BCA ASSESSMENT REPORT

**Oakdale South Estate, Horsley Park
Precinct 2**

**Prepared For:
Goodman Property Services Pty Ltd**

Revision 2

Figure 1 – Site 2A Perimeter Vehicular Access per BCA C2.4.

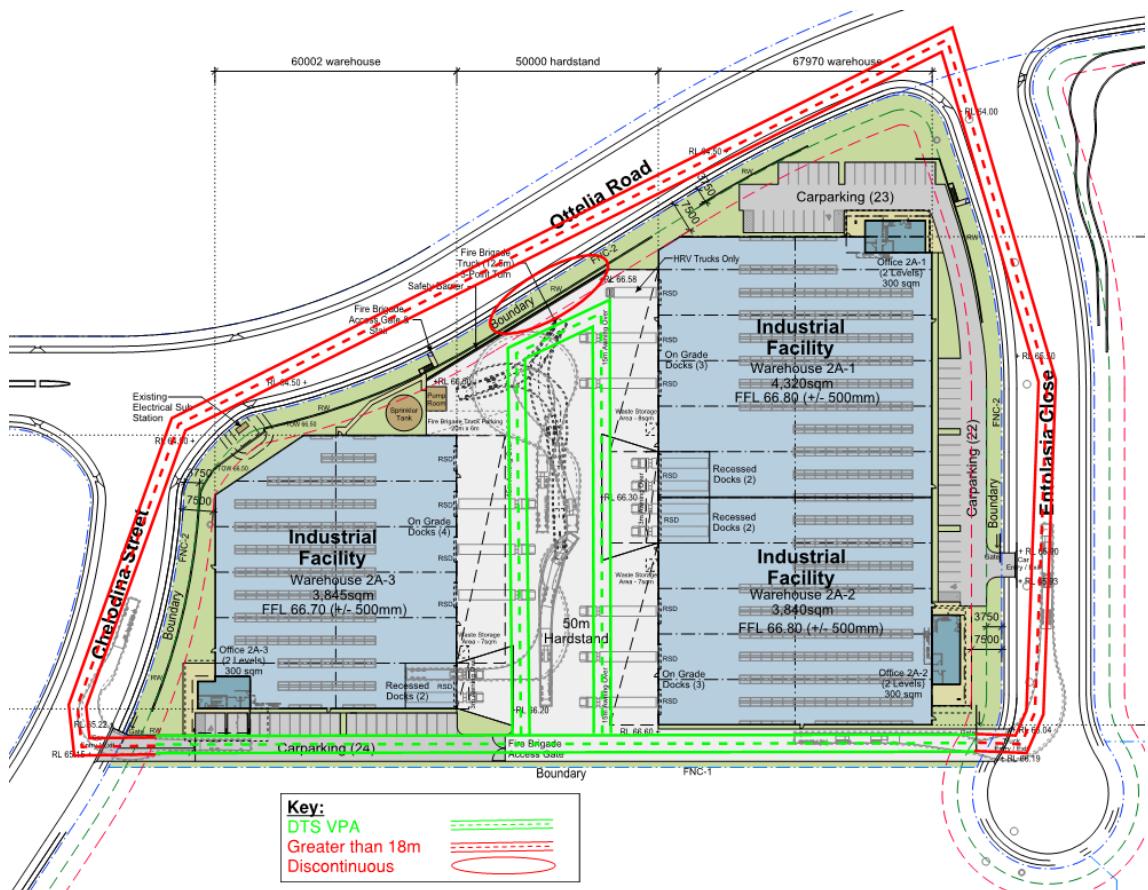
Comments: The proposed buildings do not comply with the provisions of C2.4 and thus the following non-compliance areas are identified on the site plan that are required to be addressed as an Performance Solution by the Fire Safety Engineer for each building:

- Site 2A: (i) The furthest part of the vehicular access path is greater than 18m from the external wall along Chelodina Street, Ottelia Road and Entolasia Close; (ii) Vehicular Access is discontinuous between Ottelia Road and the hardstand areas.
- Site 2B - The furthest part of the vehicular access path is greater than 18m from the external wall along Chelodina Street and Entolasia Close

Note 1: The driveways providing vehicular perimeter access must be designed with adequate loading capacities to withstand a fire truck and the gradients of the ramps should take into consideration to the FRNSW Policy 4 Vehicular Access Guideline.

Note 2: If the perimeter access paths are reduced to less than 6m in width to accommodate pedestrian egress paths per Clause D1.10 below, this will need to be documented in the Performance Solution.
